ADDENDUM No. 2 Bid No. 21-51 SUNNYSIDE HIGH SCHOOL TRACK RESURFACING

NOTICE TO ALL BIDDERS

EXHIBIT D CHUTE AREA

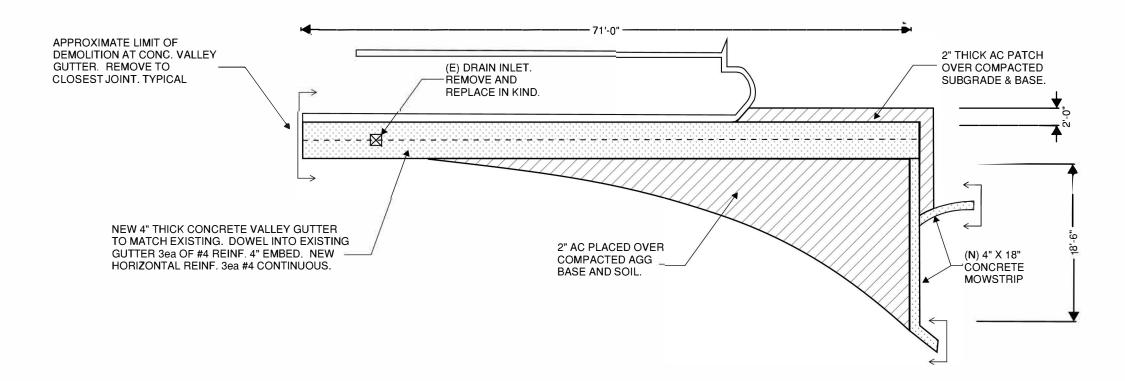
Add: Incorporate EXHIBIT D

Bidders shall incorporate attached EXHIBIT D as part of Base Bid. Contractor shall include the cost to supply and install Chute Area, as shown in attached Exhibit D.

- 1. REMOVE EXISTING CONCRETE & ASPHALT AS NECESSARY FOR NEW CHUTE AREA IMPROVEMENTS.
- 2. CAP IRRIGATION OUTSIDE OF NEW CHUTE FOOTPRINT. REESTABLISHING IRRIGATION BY DISTRICT.
- 3. REMOVE AND STOCKPILE EXISTING AGGREGATE BASE. SCARIFY AND COMPACT SUBGRADE TO 95%. SET STOCKPILED AGG BASE AND COMPACT TO 95%
- 4. TACK COAT ALL SURFACE EDGES PRIOR TO PLACEMENT OF NEW ASPHALT.
- 5. LISTED DIMENSIONS AND ELEVATIONS ARE FOR INFORMATIONAL PURPOSES ONLY. CONTRACTOR RESPONSIBLE FOR VERIFYING EXISTING ELEVATIONS & DIMENSIONS.
